53-1002165-05
21 December 2011

Fabric OS

Documentation Updates

Supporting Fabric OS v7.0.x

FIGURE 1 Decommissioned Key IDs dialog box

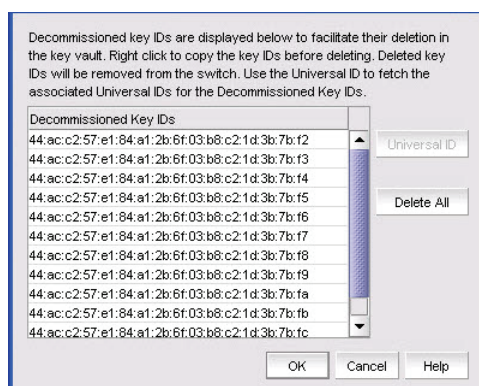
Under the heading of “Displaying and deleting decommissioned key IDs” on page 87, additional steps in the procedure have been added that must be performed from the RKM key vault server.

FIGURE 2 Universal IDs dialog box

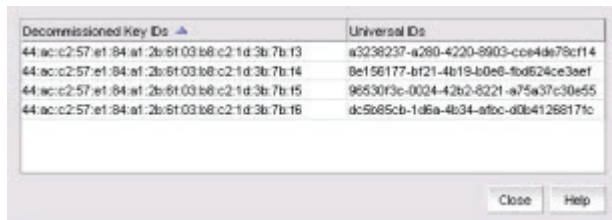
Select the desired decommissioned key IDs from the Management application **Decommissioned Key IDs** table, then click **Universal ID**. The **Universal IDs** dialog box displays.

4. Log in to the RKM key vault.
3. Click **Key Classes**.
 - a. Click **view option** for “**Key Class: kcn.1998-01.com.brocade:DEK_AES_256_XTS**”
 - b. On filters, select **UUID**, then copy and paste the UUID value of the decommissioned key.
 - c. Click **Apply**.
